Number	Description
1	Revised Table of Contents; Revised NTB Nos. 458, & 459; Added NTB No. 460; Revised Bid Items; Revised or Added Plan Sheet Nos. 2,8-10,17,3001,3004,3006,3013-3017, & 3020; Amendment EBS Download Required.

MISSISSIPPI DEPARTMENT OF TRANSPORTATION
TABLE OF CONTENTS

PROJECT: HSIP-0003-01(192)/107127301 - Hancock

ADDENDUM

SHEET NUMBER 3017

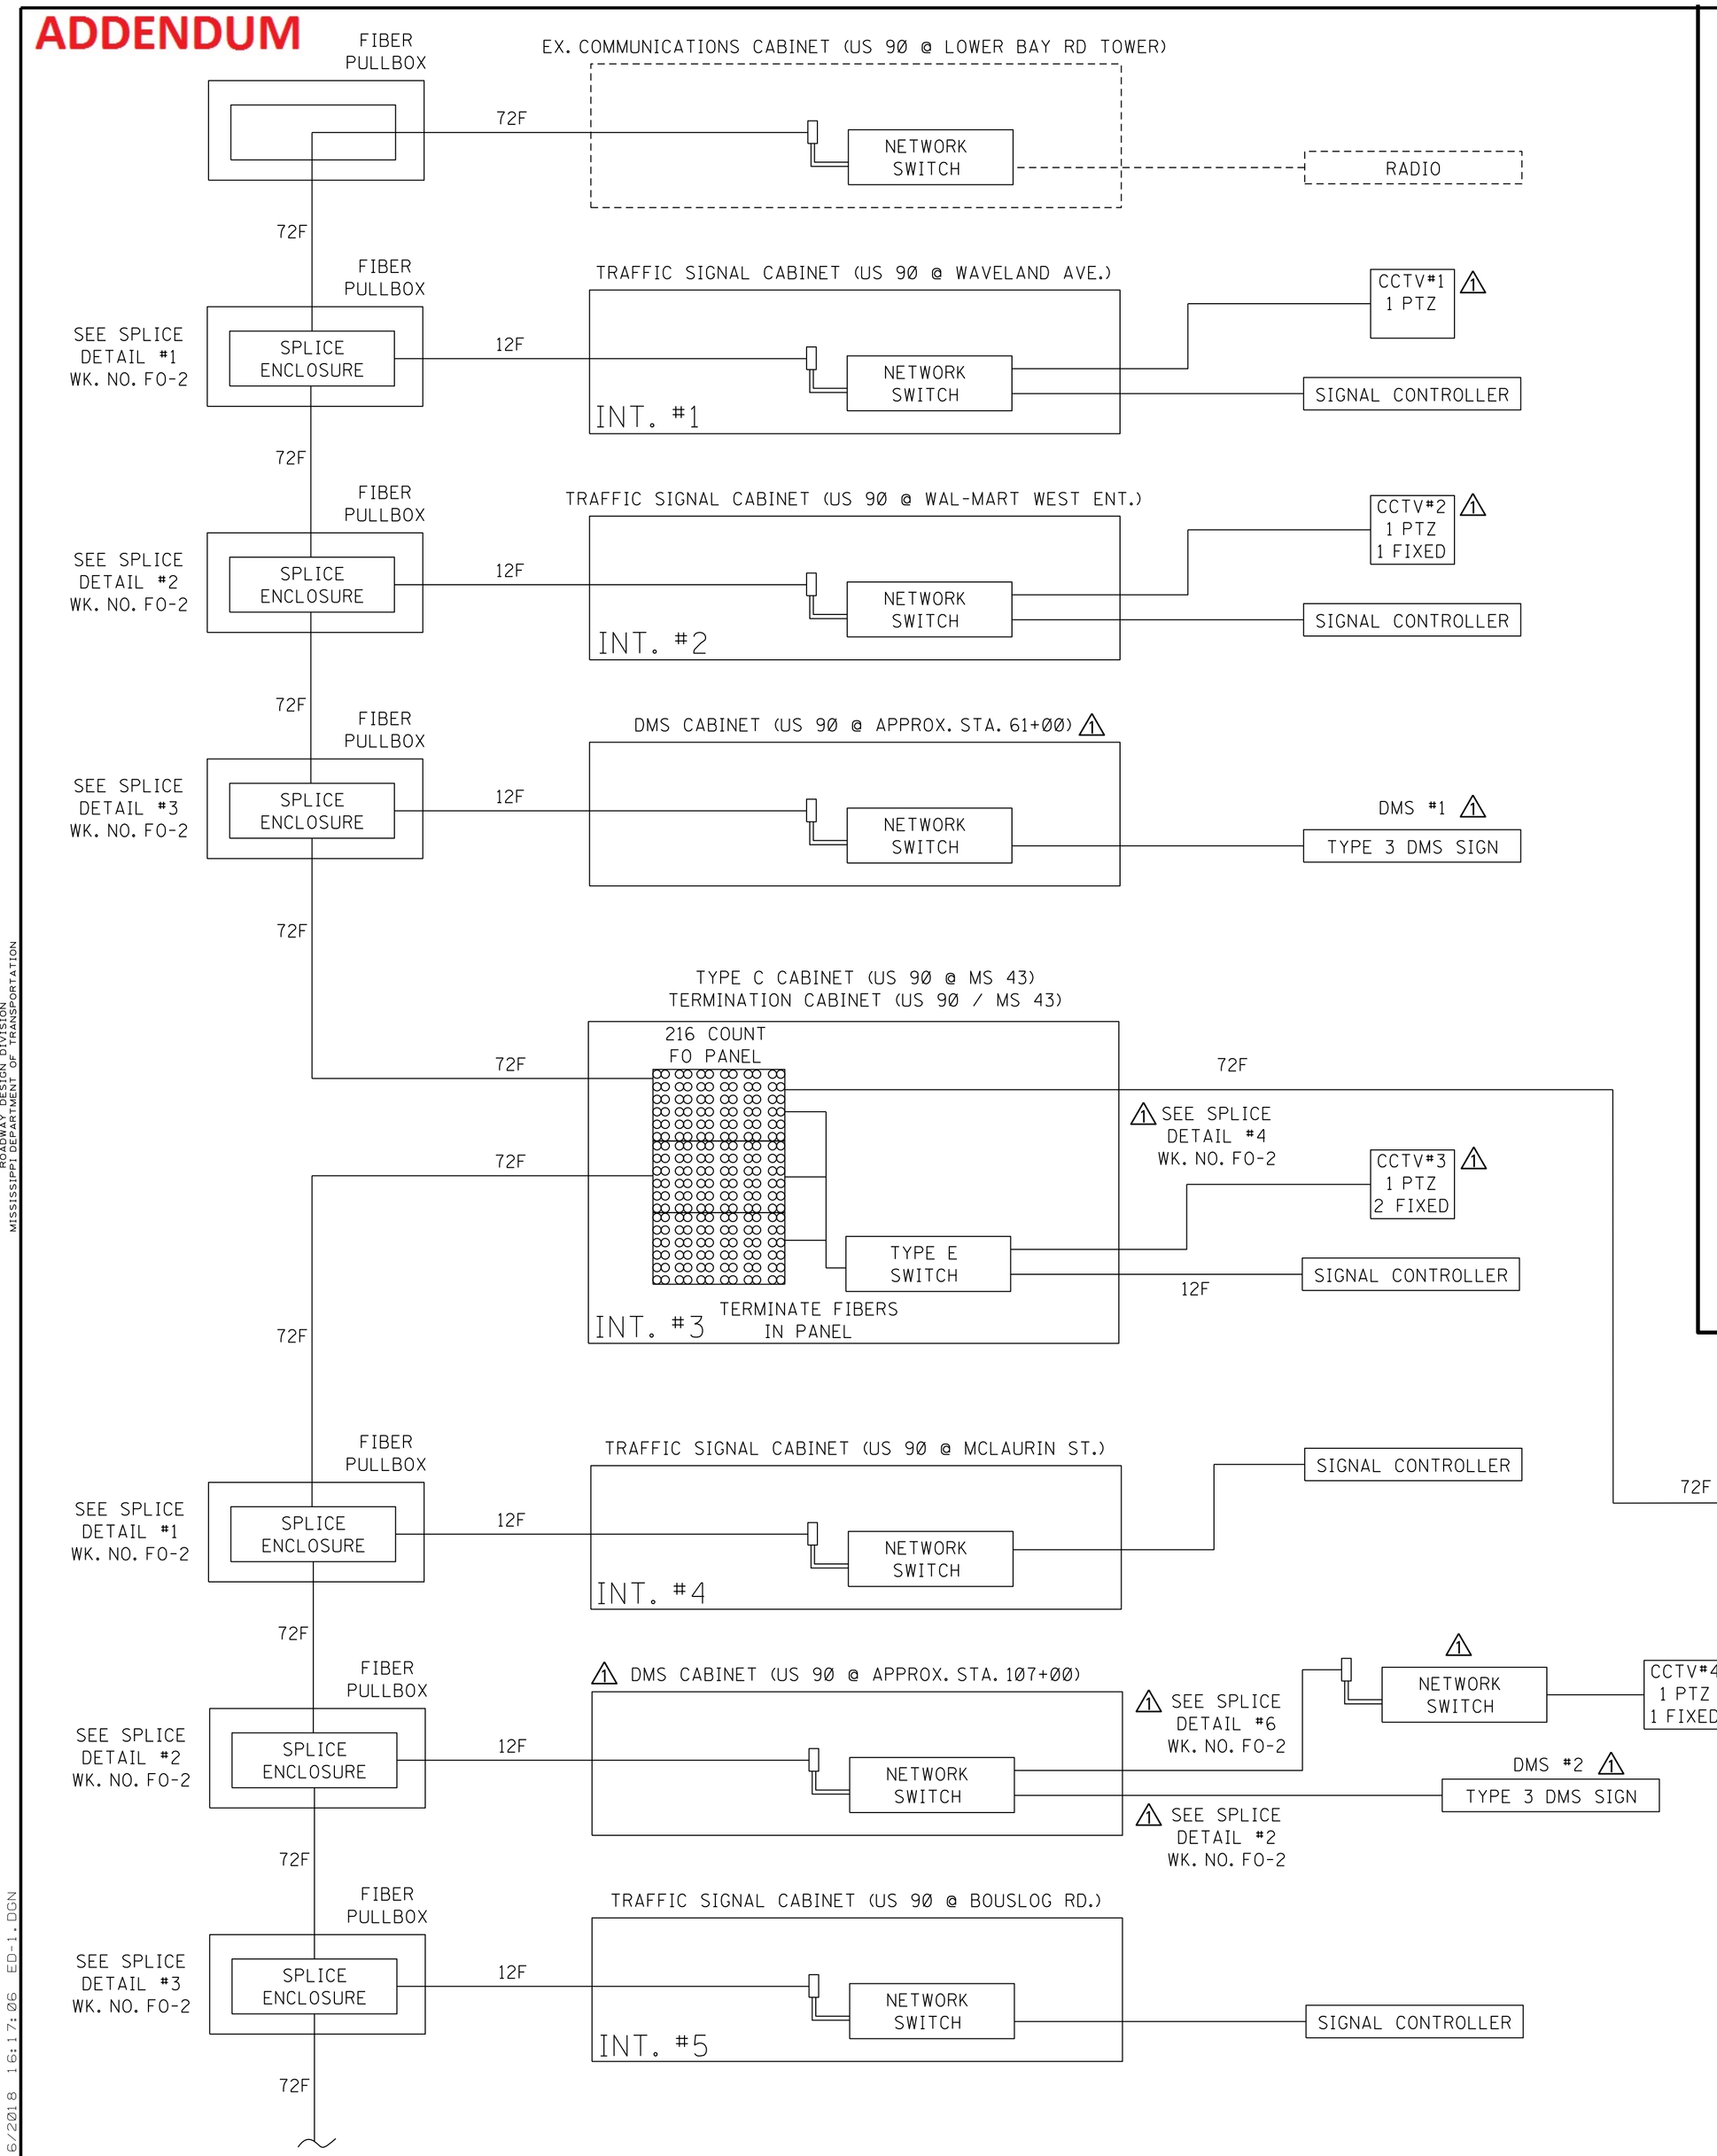
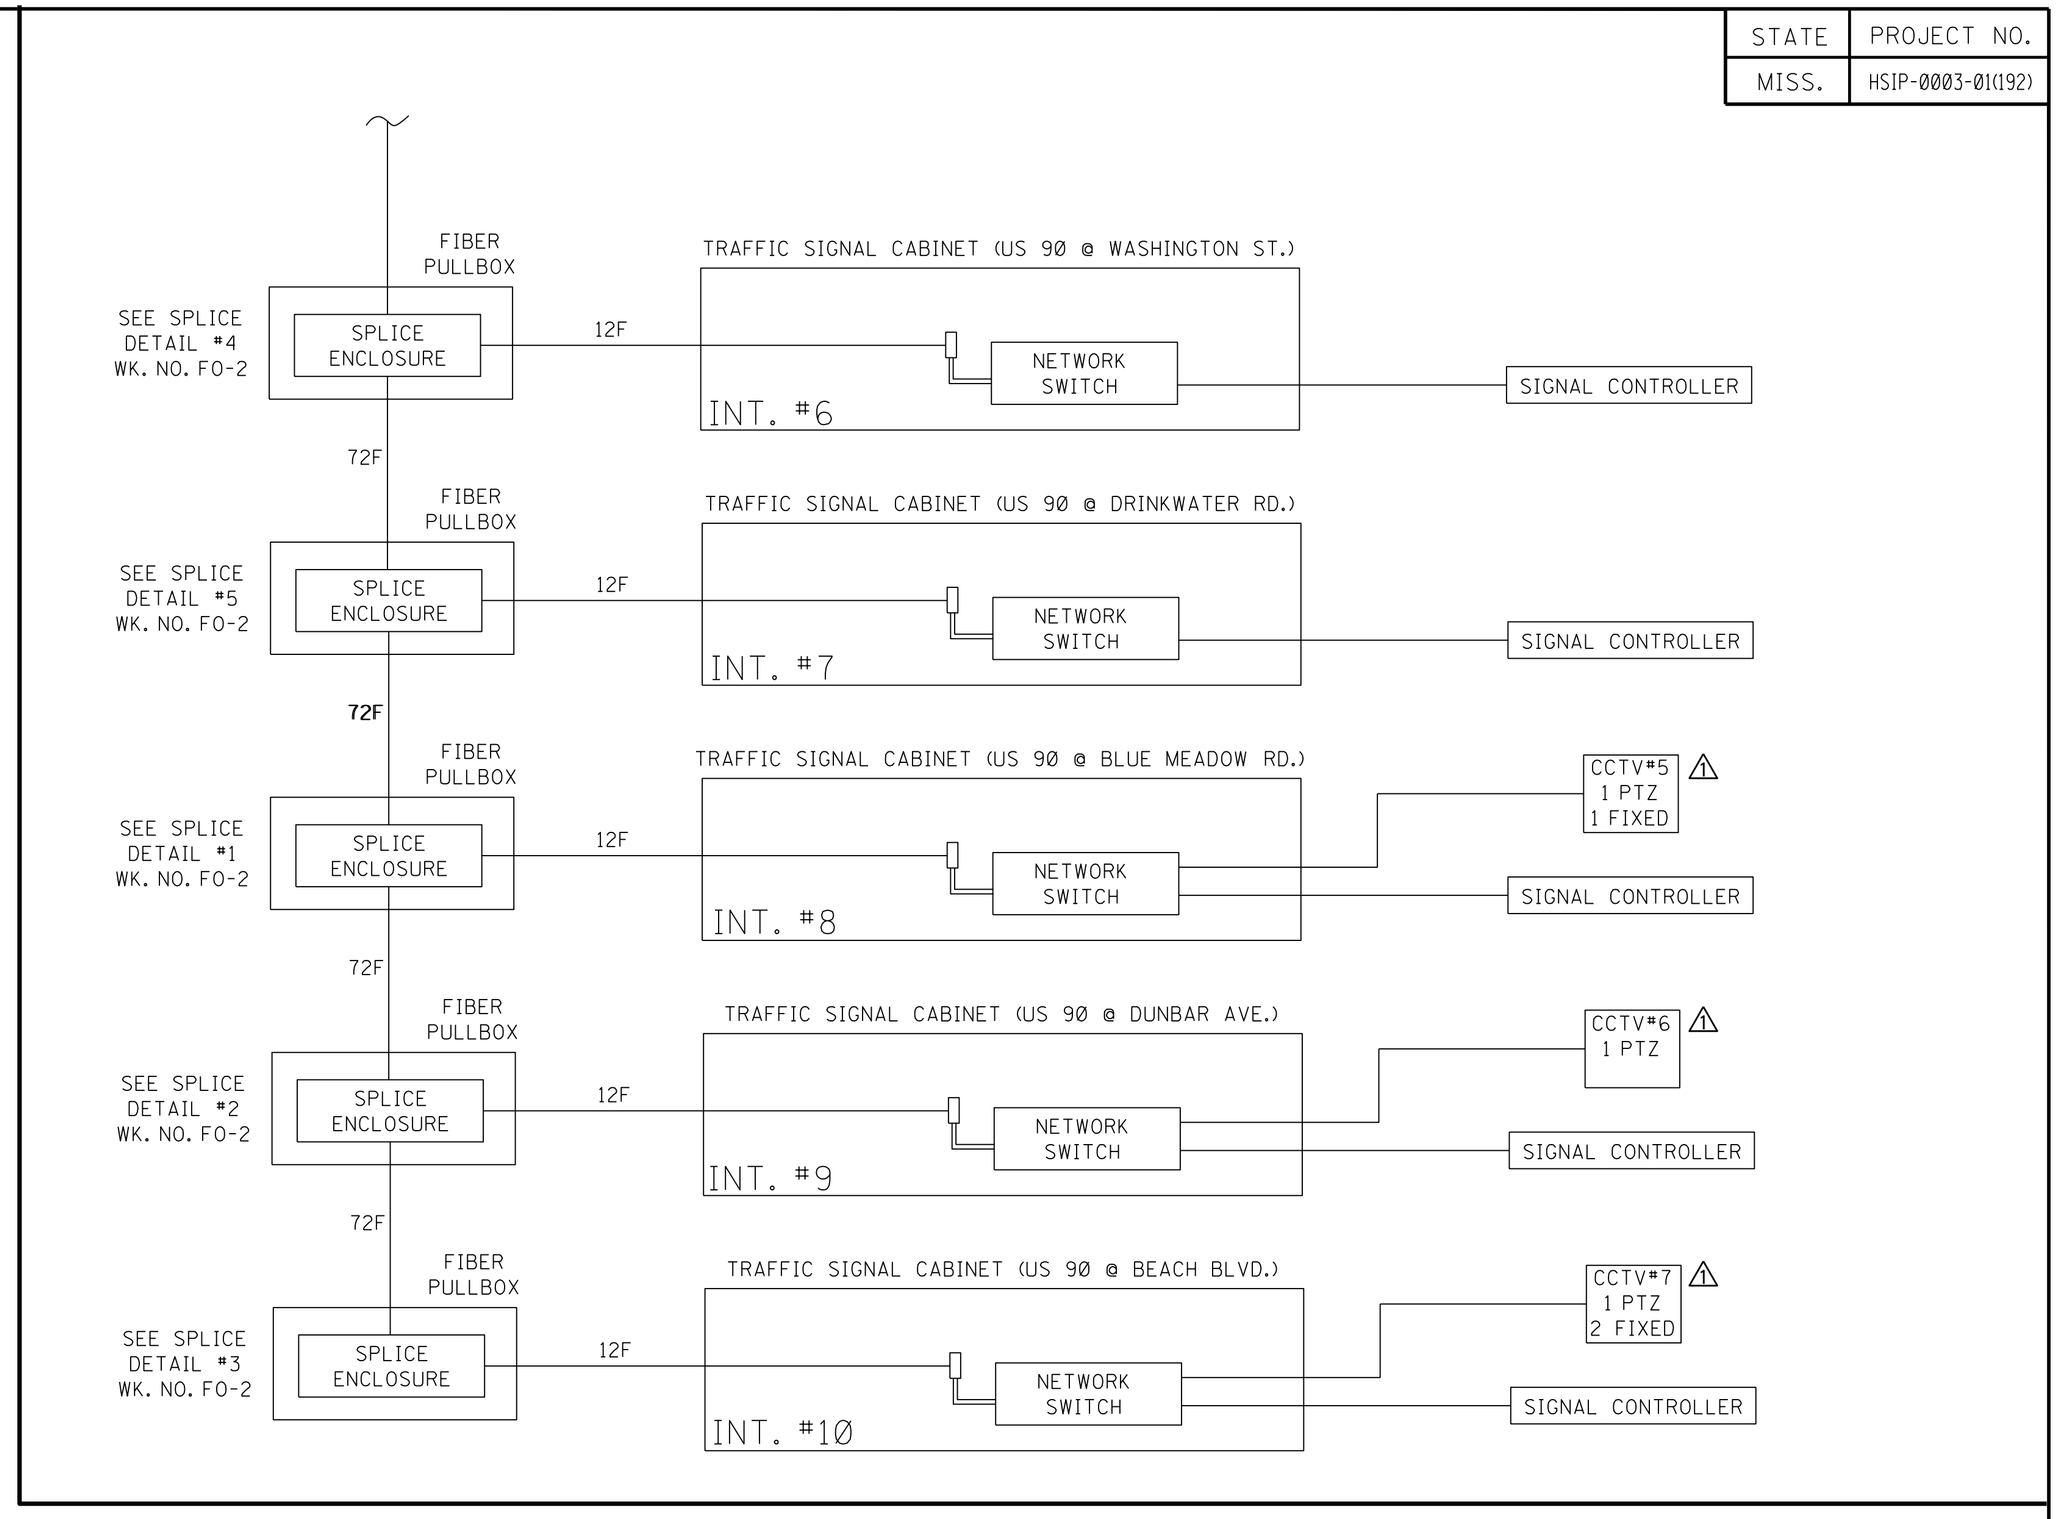
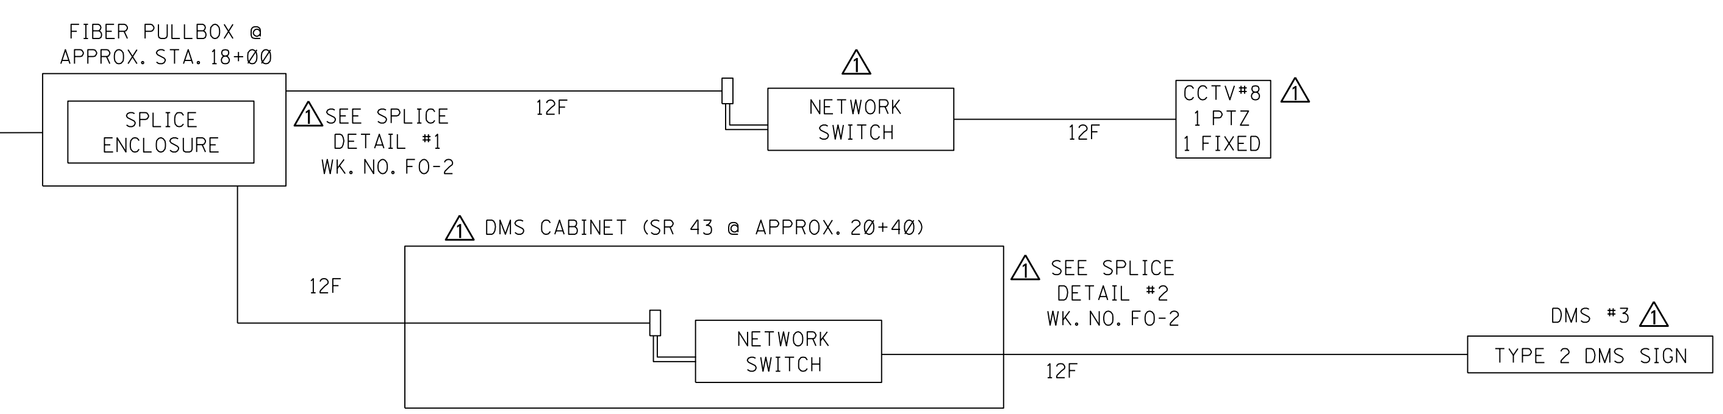
DATE	REVISION	BY	WRT
05-15-18	MODIFIED SPLICE DETAILS/DMS

SHEET NUMBER 3020

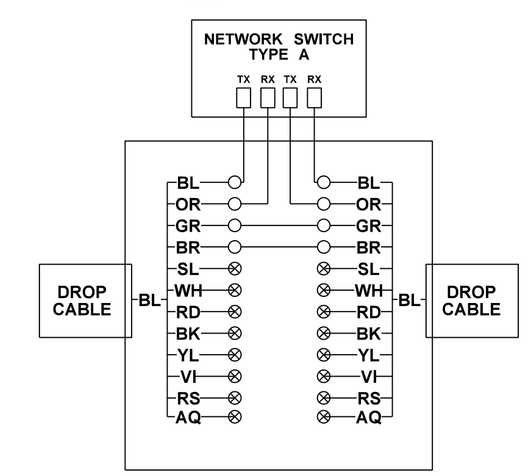
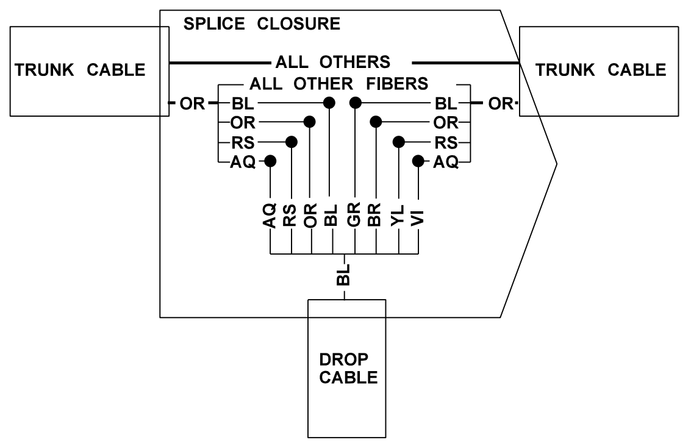
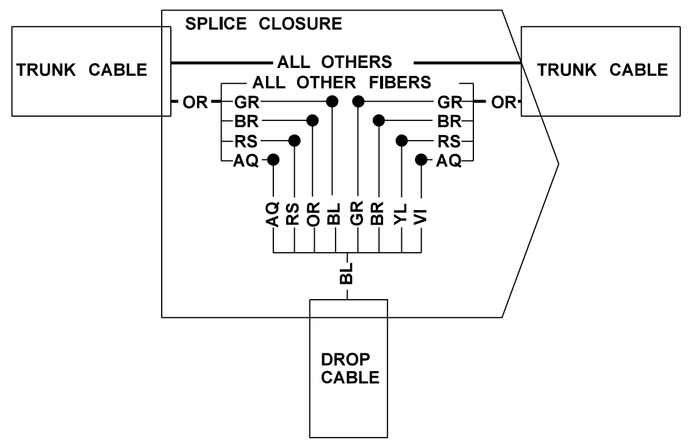
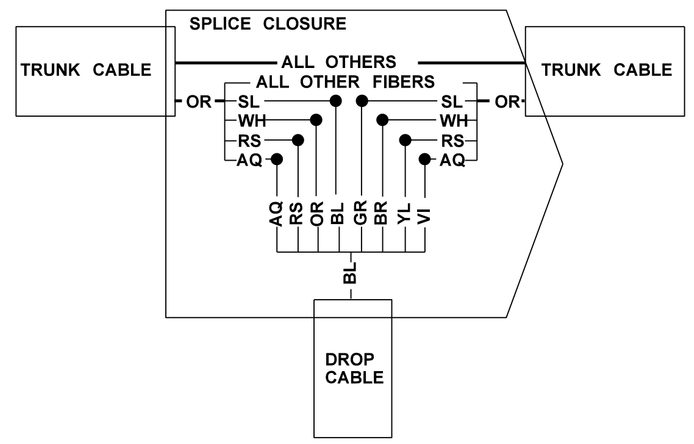
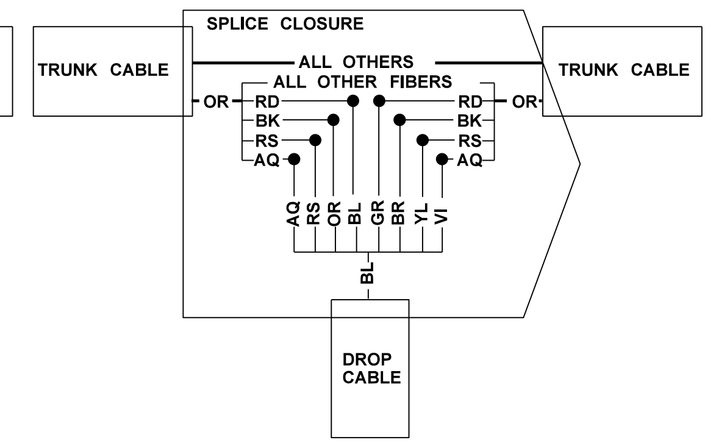
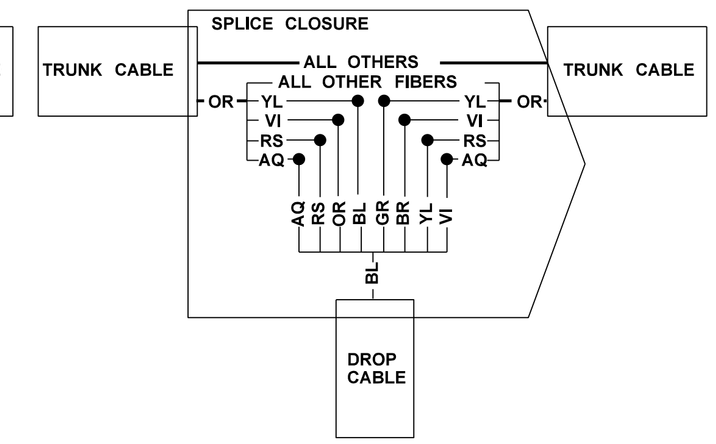
DATE	REVISION	BY	WRT
05-15-18	ADDED DETAIL 6, REVISED TABLE
